**Subject:** MHI's Responses to US-APWR DCD RAI No. 661-5129 Revision 2 (SRP 03.08.01)

Response to Request for Additional Information No. 661-5129,  
Revision 2

**RAI NO.:** NO. 661-5129 REVISION 2  
**SRP SECTION:** 03.08.01 – Concrete Containment  
**APPLICATION SECTION:** 3.8.1  
**DATE OF RAI ISSUE:** 11/15/10

**Figure 1 - Cross Section through PCCV ANSYS Model at Buttress Plot**

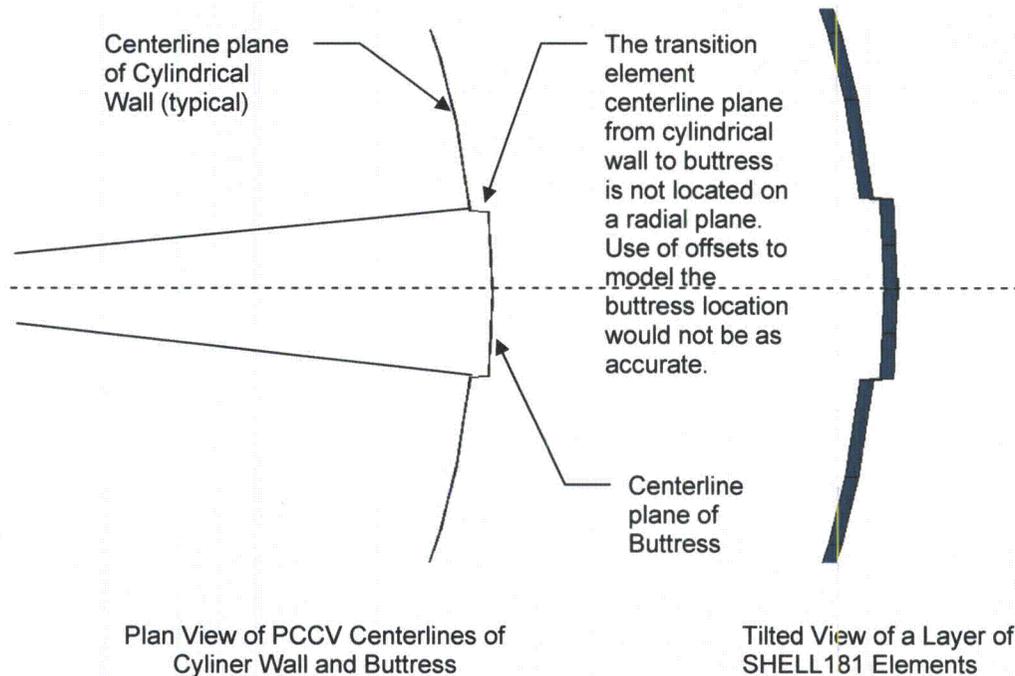
In the response to question 03.08.01-6, MHI states that plate elements will be placed at the centerline of the buttress, and shell elements with variable thickness at nodes will be used to represent the continuity of the wall to the buttress. The staff does not agree with this approach because it changes the configuration of the structure. In ANSYS Release 12, ANSYS will automatically account for the discontinuity effects due to the offset of the centerlines. MHI is requested to re-analyze this area using ANSYS Release 12 for the analyses.

MHI has applied classic ANSYS shell elements with variable-thickness transition elements located between the edge of buttress and wall of the containment due to the sloping face at the tendon anchors, which results in an accurately predicted response for the discontinuity at the buttress. MHI does not believe that there would be an advantage to re-analyze this area using ANSYS Release 12. Further detail of the current modeling of the structure and a displaced shape are presented in this RAI response to demonstrate that the current modeling accurately represents the configuration of the structure without "changing" its configuration.
